Our Ref: BNE150993

12 September 2026

Development Application:	A006295245
Property Location:	40-46 Fleming Road, Herston QLD 4006
Property Description:	Lot 9 and 10 on RP52955 and Lot 1 on RP98578
Development:	Request to Change a Development Approval under Section 81 of the Planning Act 2016 – A006295245
Client:	Unison Projects No. 3 Pty Ltd

Figure 4 – Approved (left) and Proposed (right) Front Façade – Lot 1 House

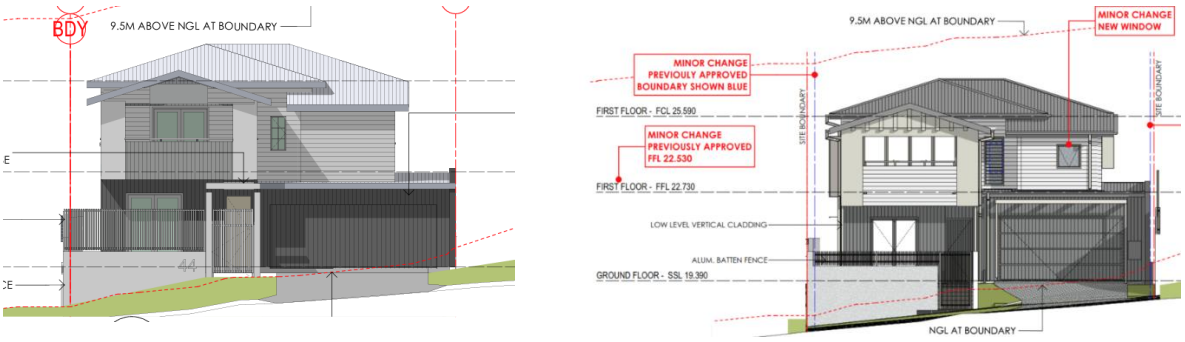
Changes to the dwelling house on approved Lot 2 include minor cosmetic refinements (such as revised window configurations) which maintain compliance with the Traditional Building Character (Design) Overlay Code.

Minor adjustments to the floor levels are also proposed, with the building height remaining well below the prescribed 9.5m above ground level.

Figure 6 – Approved (left) and Proposed (right) Ground Level 1 plan

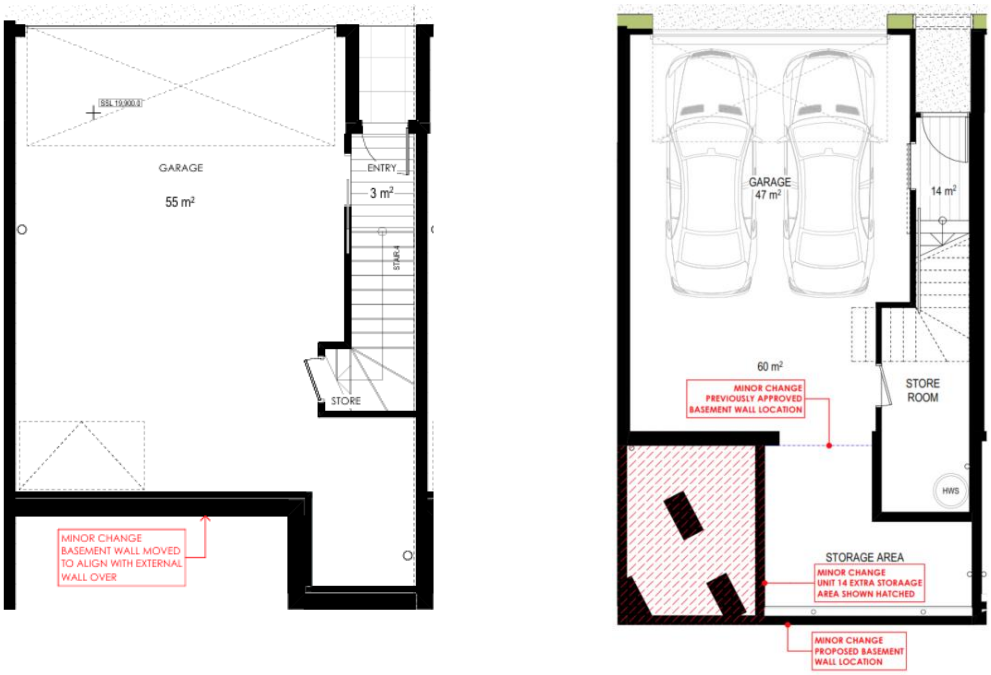
The basement wall will be shifted closer to the western boundary to provide additional storage at Ground Level 1 as illustrated in **Figure 6** below. This will increase the total unit area from 228m^2 to 244m^2 for Unit 13 and 254m^2 for Unit 14, which includes a larger storage area. As the additional area results from the shifting of underground basement wall, there will be no increase in bulk or scale.

Figure 7 – Approved (left) and Proposed (right) Ground Level 1 plan

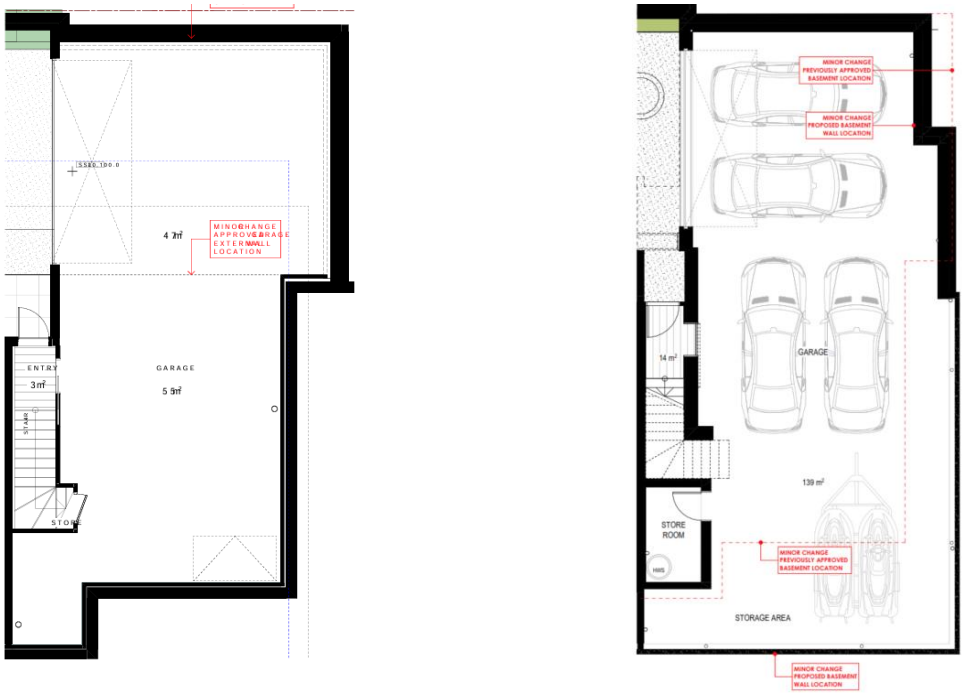
The southern basement wall will be stepped in, while the western basement wall will extend closer to the boundary to provide additional storage. Adjustments to the Level 2 retaining walls will modestly reconfigure the terrace and courtyard, and a new window is proposed on the southern elevation beside the dining room. The total unit area will increase from 347m^2 to 378m^2 as a result of the basement wall changes, which will not impact on the building bulk and scale.
